# ARCHITECTURAL REVIEW COMMITTEE MEMORANDUM

DATE: JULY 18, 2022 NEW BUSINESS

SUBJECT: REQUEST BY RICHARD MEANEY (OWNER), FOR A MAJOR ARCHITECTURAL APPLICATION TO CONSTRUCT A 4,000-SQUARE-FOOT SINGLE-FAMILY RESIDENCE ON A HILLSIDE LOT LOCATED ON LOT 64, 2085 DESERT FLOWER COURT (APN: 504-400-008), ZONE ESA-SP, SECTION 4 (CASE 3.4328 MAJ). (GM)

**LED LANDSCAPE LIGHTING PLAN**  
 SCALE: 1 / 8" = 1'-0"

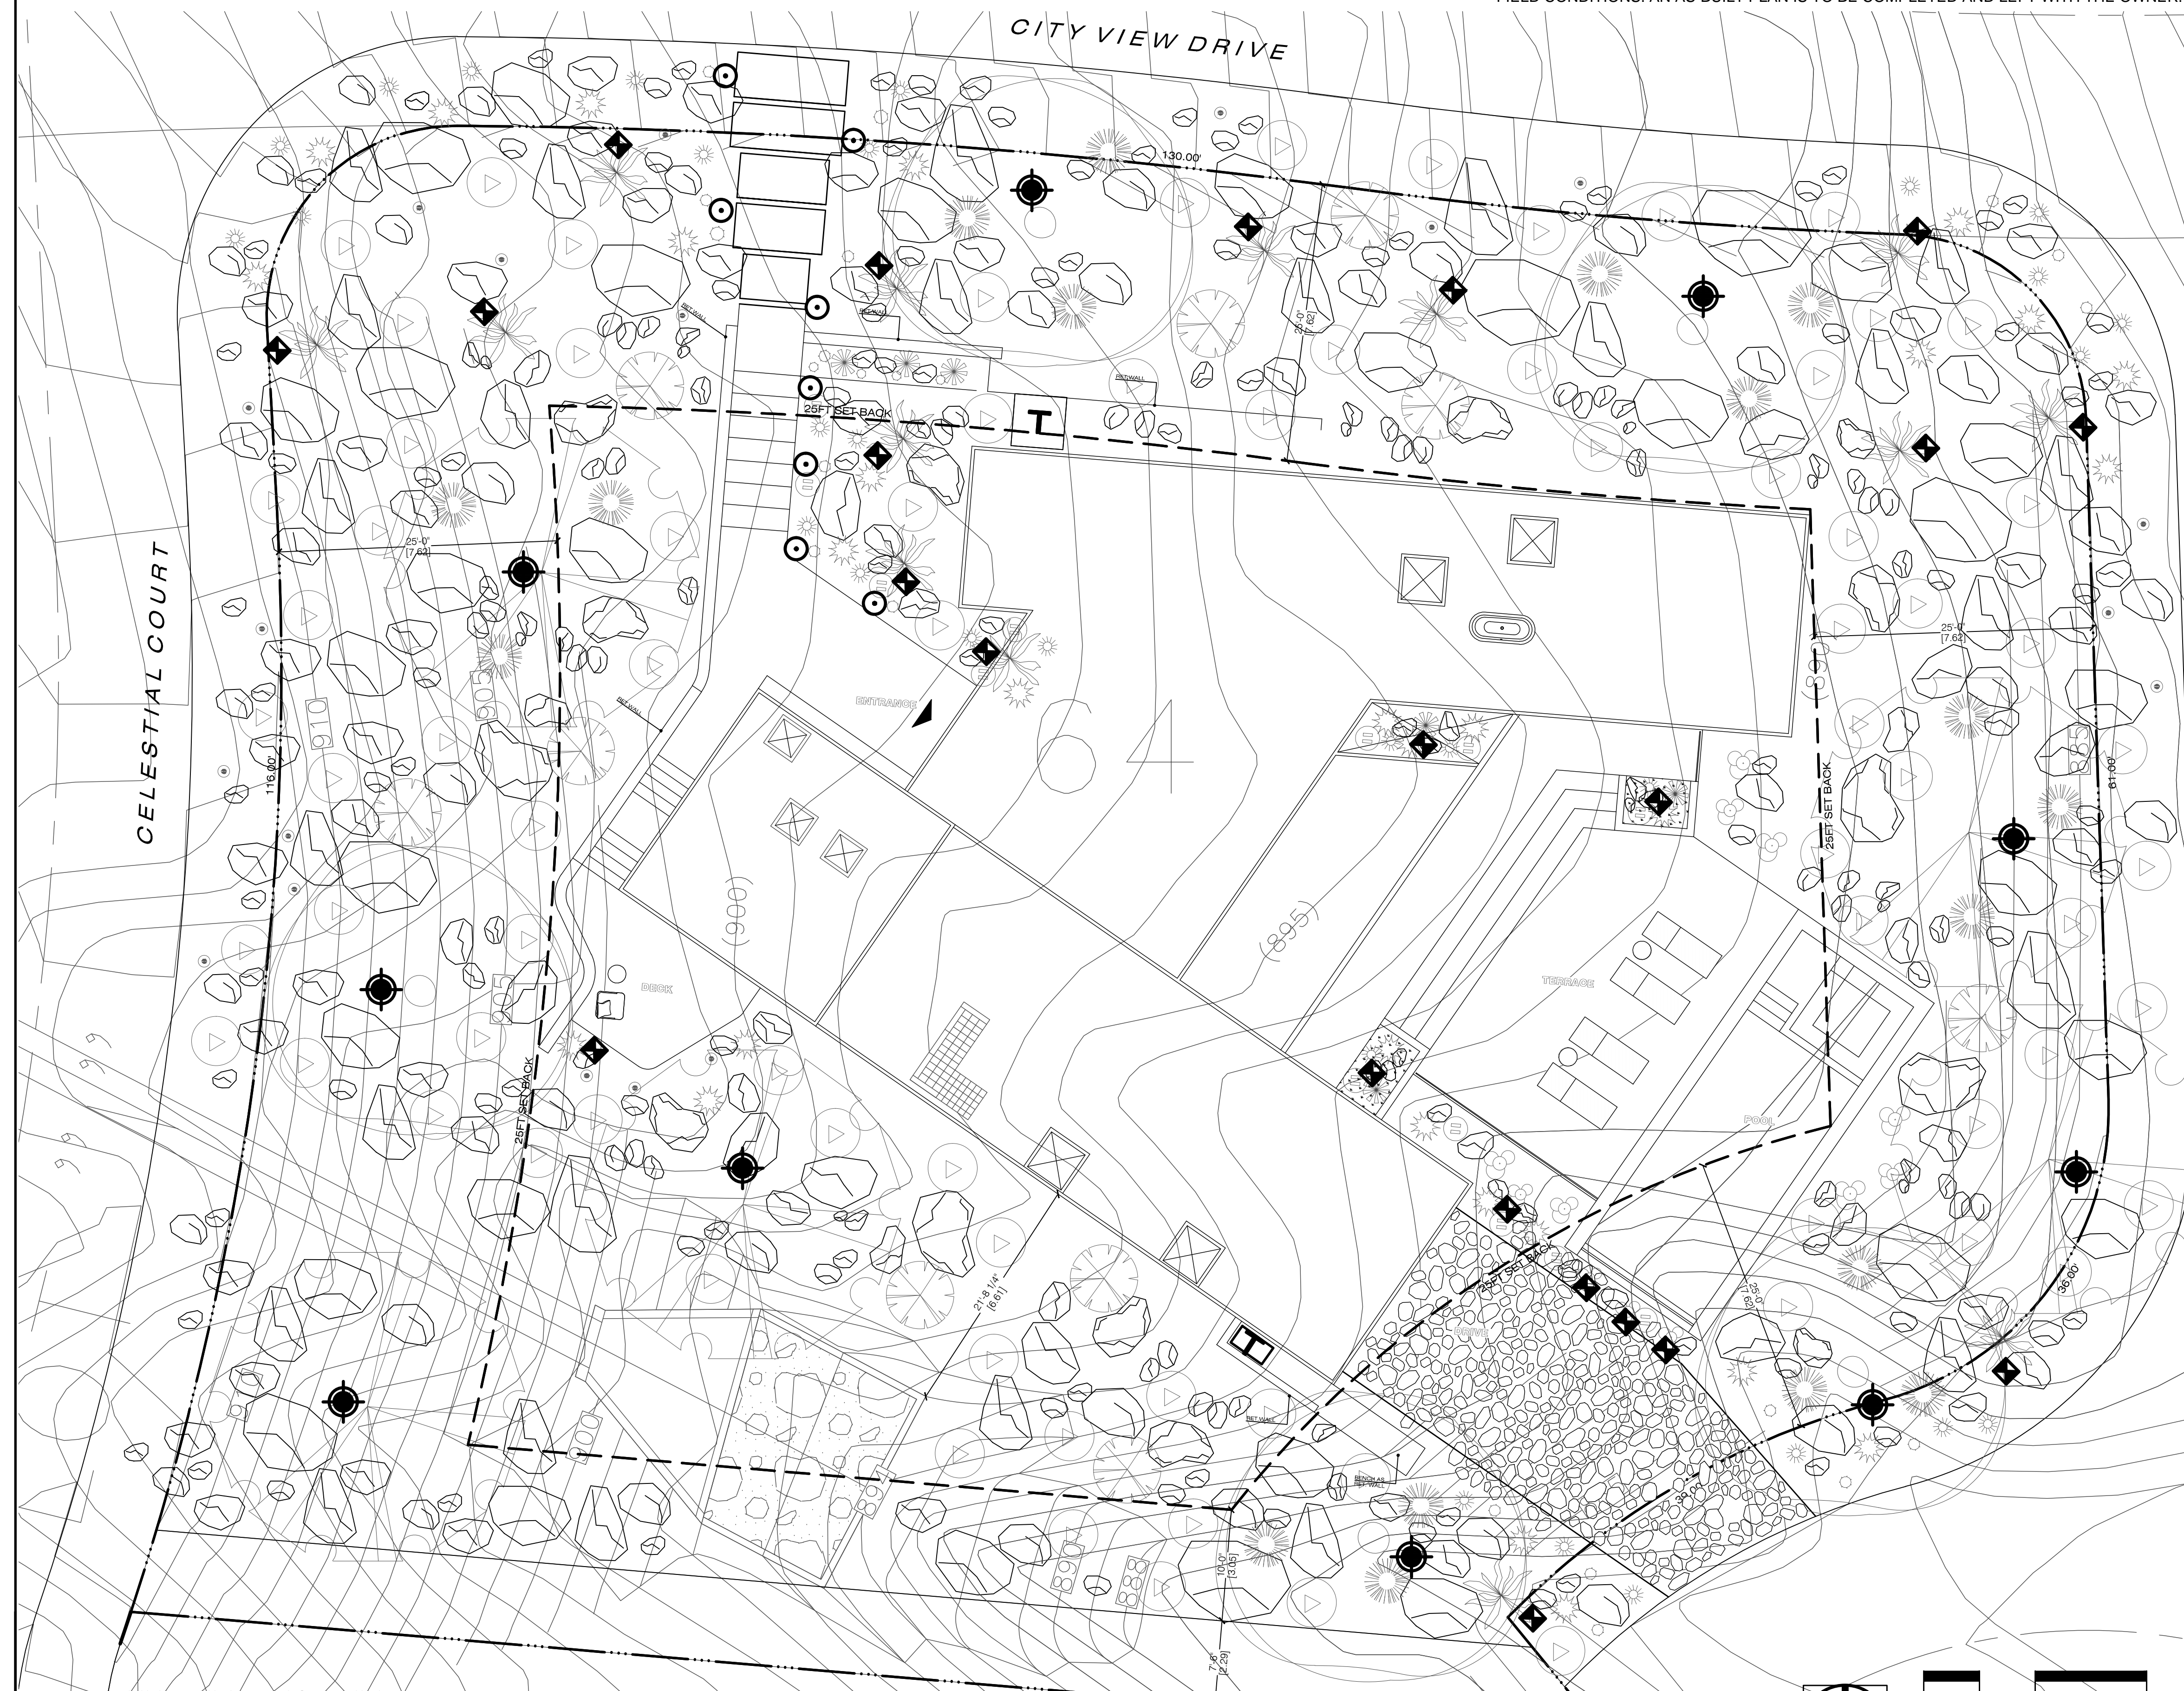
10.	<p><i>The proposed lighting plan is consistent with the requirements of PSZC Section 93.21.00, and the proposed lighting will not materially impact adjacent properties;</i></p> <p>The project proposes a variety of landscape light fixtures, which include but are not limited to, twenty-two (22) accent lights, and ten (10) trees up lights at low levels or brightness. The ARC may recommend that the number of lights be reduced to prevent glare at the hillside.</p>	Y

- PLN 2. Outdoor Lighting Conformance. Exterior lighting plans, including a photometric site plan showing the project's conformance with Section 93.21.00 Outdoor Lighting Standards of the Palm Springs Zoning ordinance, shall be submitted for approval by the Department of Planning prior to issuance of a building permit. Manufacturer's cut sheets of all exterior lighting on the building and in the landscaping shall be included. If lights are proposed to be mounted on buildings, down-lights shall be utilized. No lighting of hillsides is permitted.
